Interactive comment on “Quantification and mitigation of the impact of scene inhomogeneity on Sentinel-4 UVN UV-VIS retrievals” by S. Noël et al.

Reply to referee 1

Fig. 1. Normalised spatial response function for the UV-VIS in east-west direction in ground coordinates. Red: Without scan. Green: With scan.

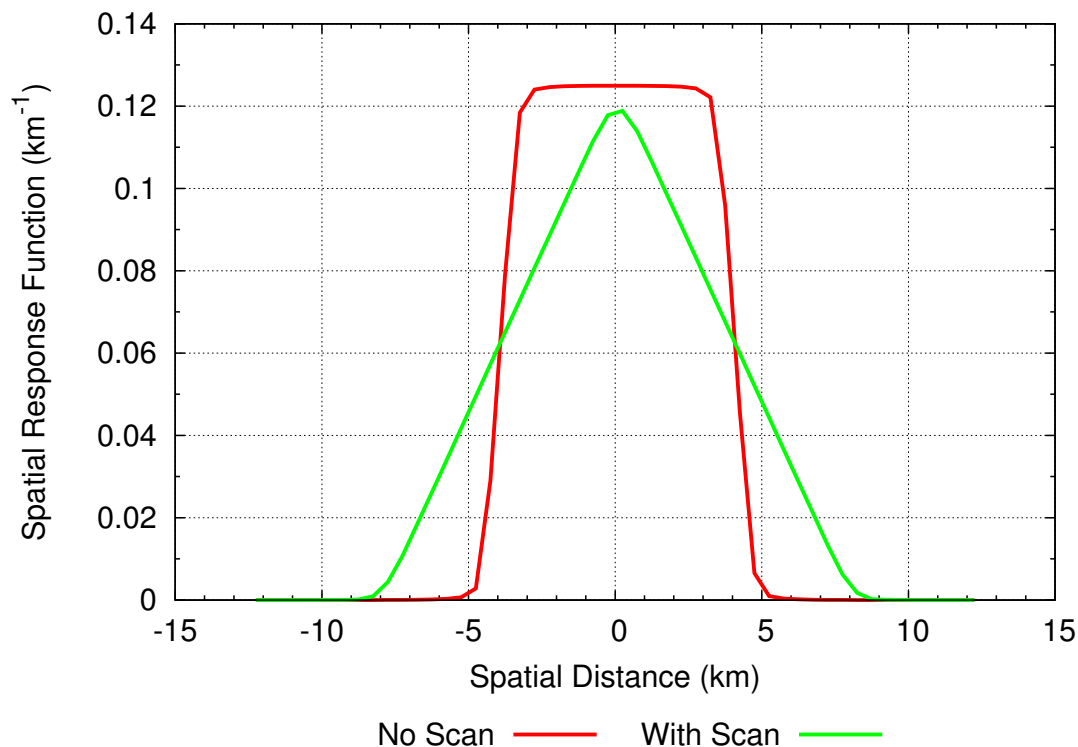
3. *Page 2046, lines 5-12: Explain in more detail what the UVN instantaneous field of view is, how it scans from east to west over 8 km in about 6 seconds and what the convolution of the 2 looks like, since this is important to understand the impact of scene inhomogeneity of instrument spectral response.*

The typical UVN ground sample size is $8 \text{ km} \times 8 \text{ km}$. The spatial response function of the UVN instrument in east-west direction is shown in Fig. 1, giving the sensitivity of the instrument to light coming from different directions / spatial distances relative to the centre of the observed scene. As can be seen from this figure, the spatial response function is in the UV-VIS of trapezoidal (almost rectangular) shape with a full width at half maximum (FWHM) of about 8 km. During one integration time (about 6 s) the instantaneous field of view (IFOV) is moved about 8 km from the east to the west by the scan. By this the spatial response function is smeared, resulting in an almost triangular shape (but with similar FWHM).

This is added to the manuscript appropriately.
